PERMIT

SEWAGE DISPOSAL SYSTEM

REPAIR - PURPOSE - SEPTIC SYSTEM HAS FAILED

OWNER: Dell? PHONE #: 410-259-2033
ADDRESS: 481? Sykesville Rd CONTRACTOR: Dan Fisher
House directly South of 465 Rt 32 shares a drive WELL TAG #: N/A
SUBDIVISION: N/A LOT: _____ COUNTY #: _____
PROPOSAL: Demo existing house but keep existing well

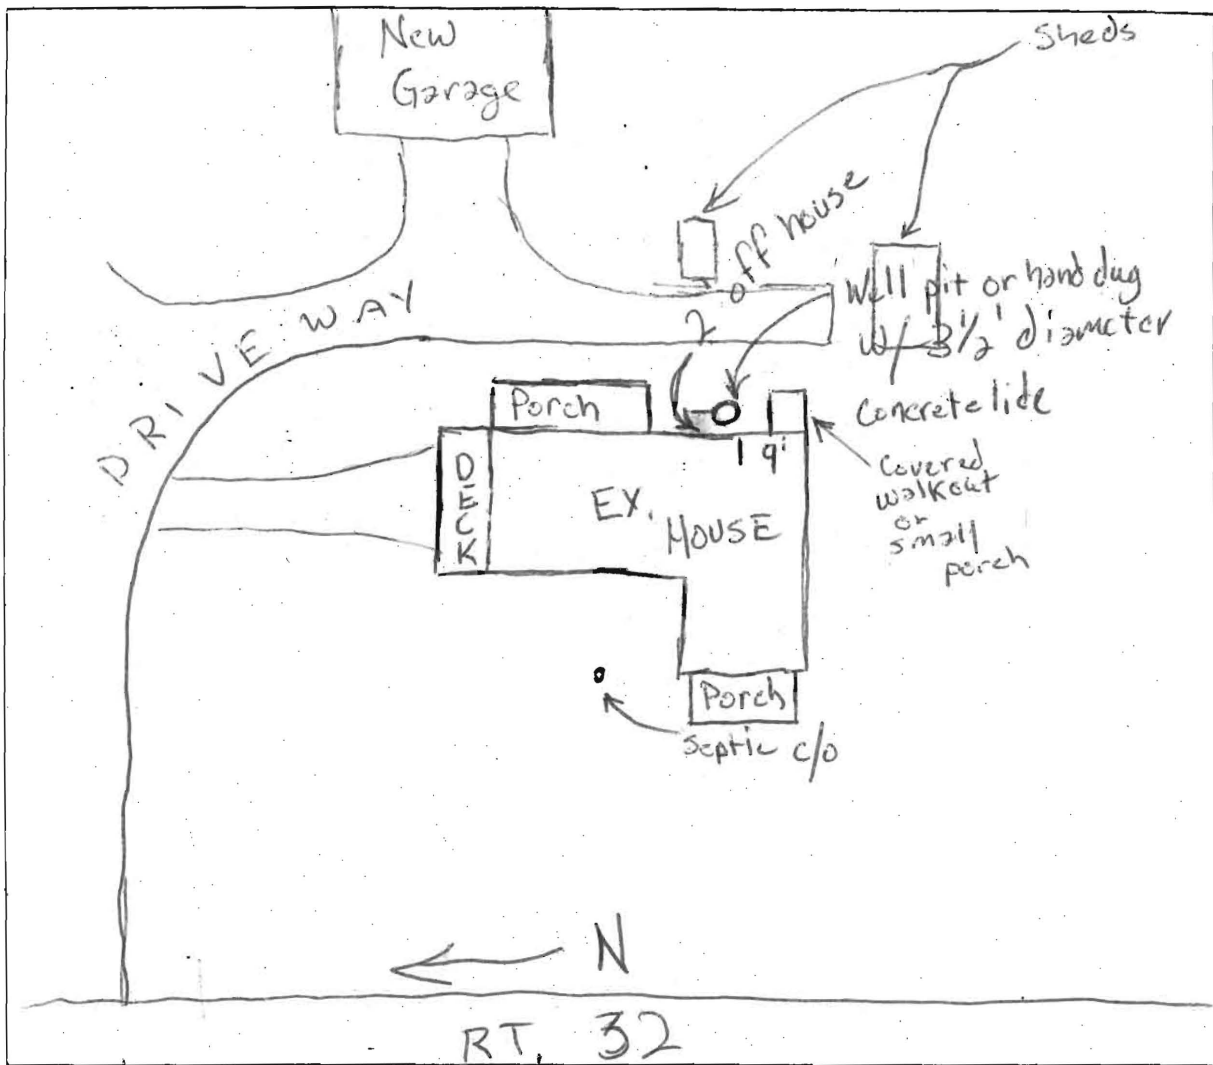
REMARKS: Existing dry well lid is 3'5" below grade. Drywell water level at 5 ft below lid at

System already installed & covered, Diagram based contractor's information per T/C 4/19/96

LOCATION DIAGRAM

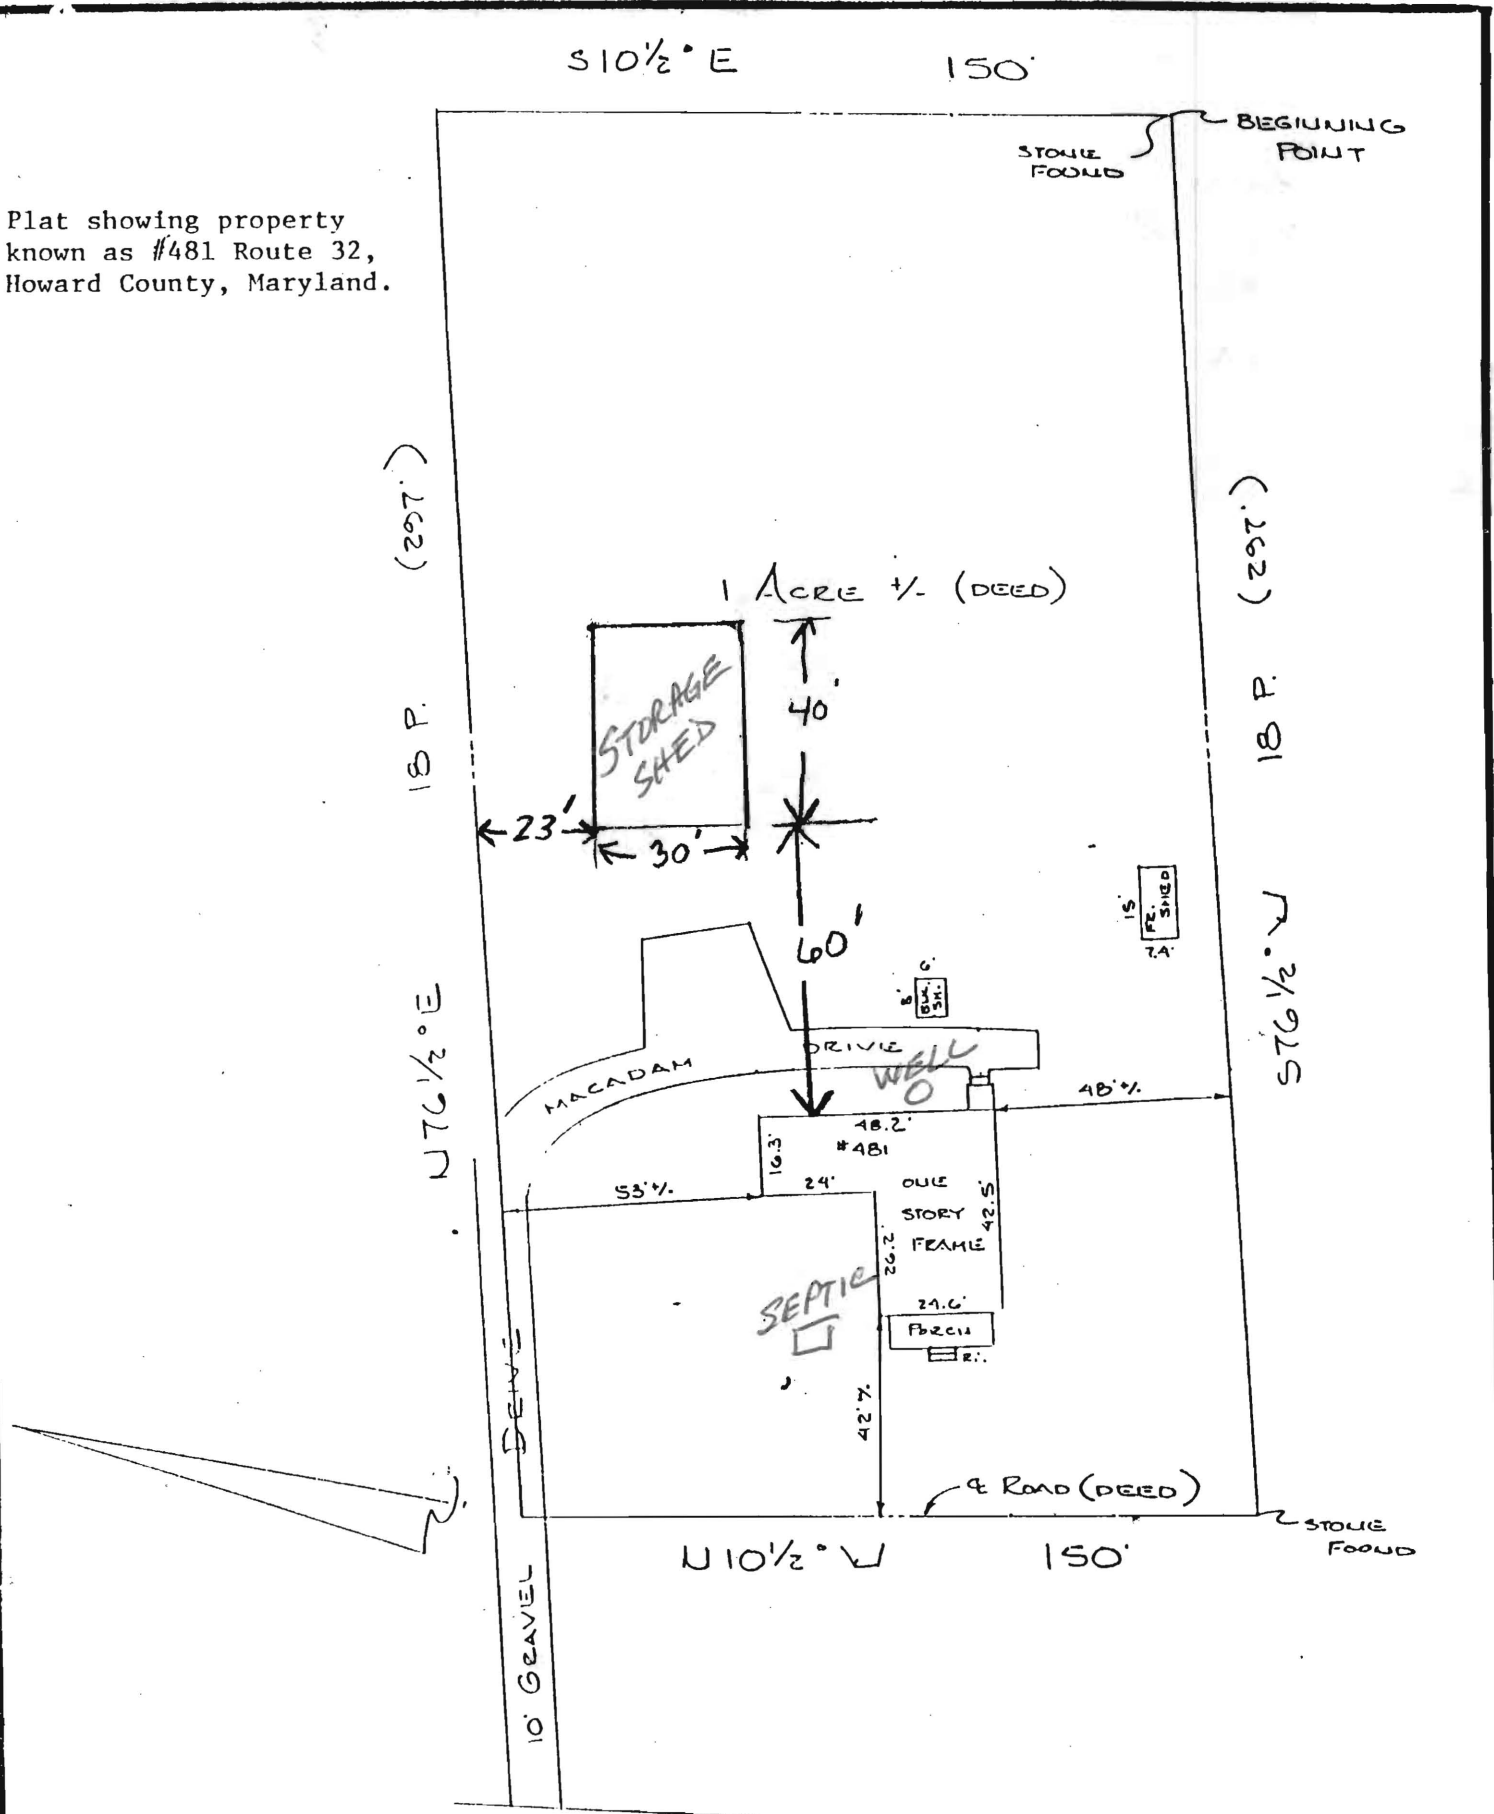
COMMENTS: Well is not up to current specs.
Must be abandoned or brought up to specs. (GAC)
